Memorandum of Advice

Traffic Generation from Proposed Gunnedah Recycling & Resource Recovery Facility

The following responses to Department of Planning and Environment request for further information have been provided by StreetWise Road safety & Traffic Services.

B-double turnpath assessment – Upgraded Torrens Rd access (Martens & Assoc)

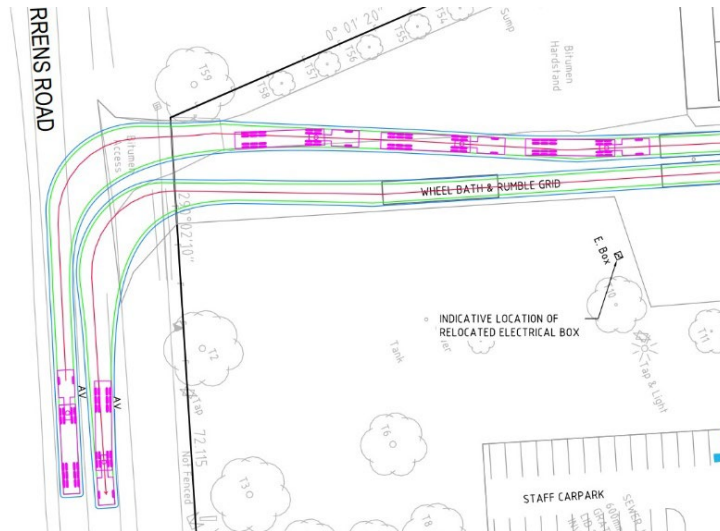
"Confirm the largest vehicle expected to enter the site and provide swept paths for this vehicle. Please provide swept path diagrams showing vehicles exiting the site onto Torrens Road."

"Describe how site traffic will be managed when a B double or B triple (as shown in swept path diagrams) is turning right to enter the site as other vehicles would not be able to exit simultaneously based on the current width of the driveway."

The design plans for the future Recycling & Resource Recovery Facility have been updated. The amended plans show details of the upgraded driveway / access from Torrens Road into the site, as well as turnpaths for B-double vehicles. As can be seen from the image below, and the swept-paths provided by Martens & Associates, the widened driveway provides adequate width for all heavy vehicles to turn safely in and out of the site, without the need to cross the Torrens Road centreline.

See swept turnpath by Martens & Associates above. Also, when the Waste Facility is approved and completed, the operators will prepare a Traffic Management Plan, Vehicle Movement Plan and Driver's Code of Conduct for the site and related activities. This will show the safe access in & out of the site, as well as required movements within the site. The traffic plans & documents will provide directions for safe movements, parking and activities for all drivers, and is likely to include signage, linemarking, scheduling of all heavy vehicle movements and instructions for 2-way radio operations.
